Technical Service Bulletin: tsb100497

Released Date: 09-Aug-2006

New Fuel Lift Pump Gasket

Early-Style Lift Pump Gasket

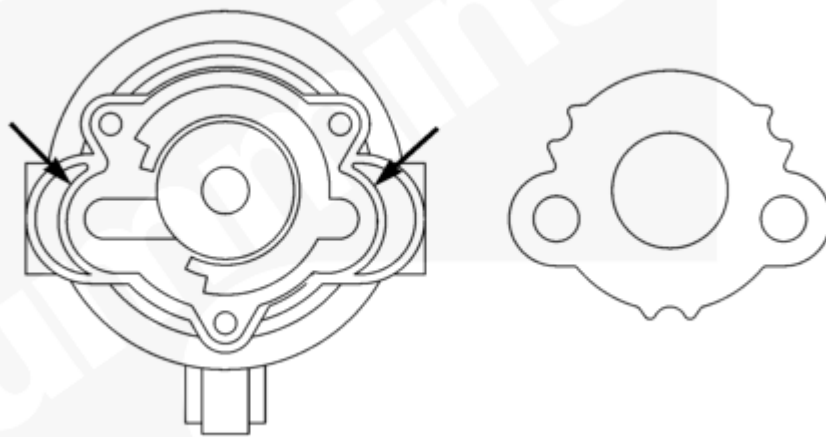
This lift pump housing takes gasket Part Number 4928511.

The early-style lift pump service gasket, Part Number 4928511, can **only** be used on lift pump, Part Number 4076857, and lift pump part numbers built before the dates in the table below.

New-Style Lift Pump Gasket

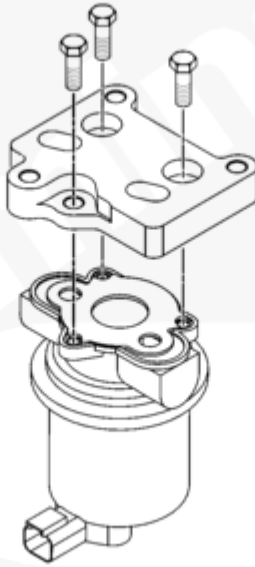
This lift pump housing takes gasket Part Number 4928512.

The gasket is located between the adapter and the lift pump housing.

The new-style lift pump service gasket, Part Number 4928512, can **only** be used on lift pump part numbers built on or after the dates listed in the table below.

ISX Fuel Lift Pump Serial Number

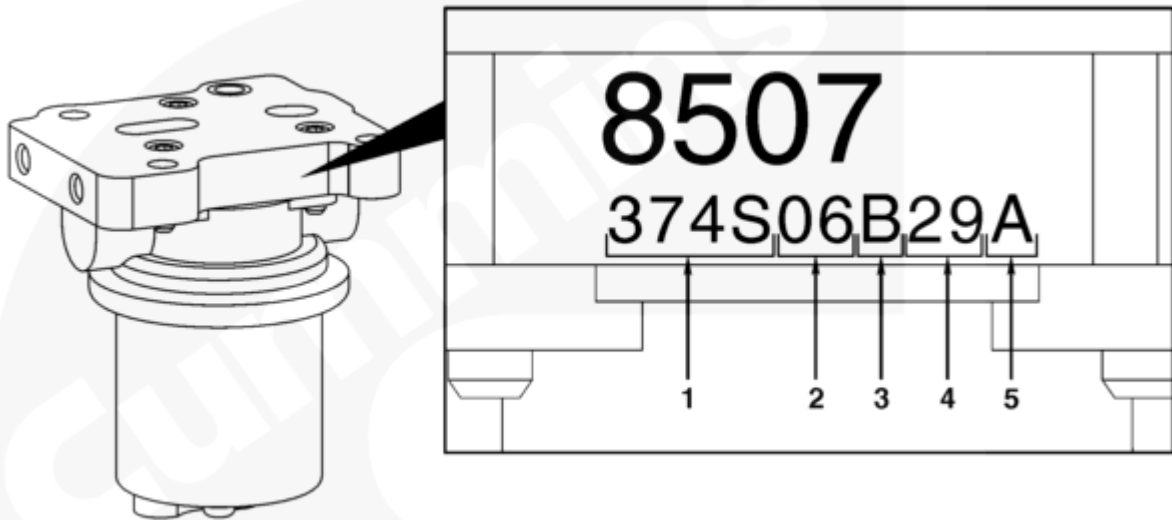
The ISX lift pump serial number is interpreted as follows:

1. Last four characters of the supplier part number
2. Year
3. Month
4. Day
5. Shift

For example, 374S06B29A is an ISX lift pump built on February 29, 2006 during the first shift. This lift pump will use gasket Part Number 4928512 because it is after the dates listed in the table below.

ISC/ISL Fuel Lift Pump Serial Number

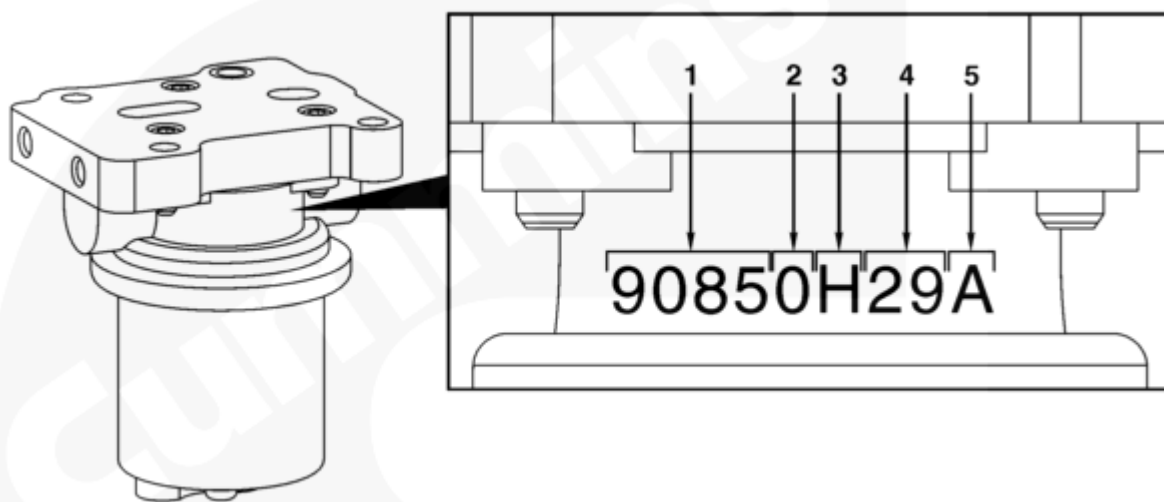
The ISC/ISL lift pump serial number is interpreted as follows:

1. Last four digits of the Cummins part number
2. Year
3. Month
4. Day
5. Shift

For example, 90850H29A is an ISC lift pump built on August 29, 2000 during the first shift. The lift pump will use gasket, Part Number 4928511, because it is before the dates listed in the table below.
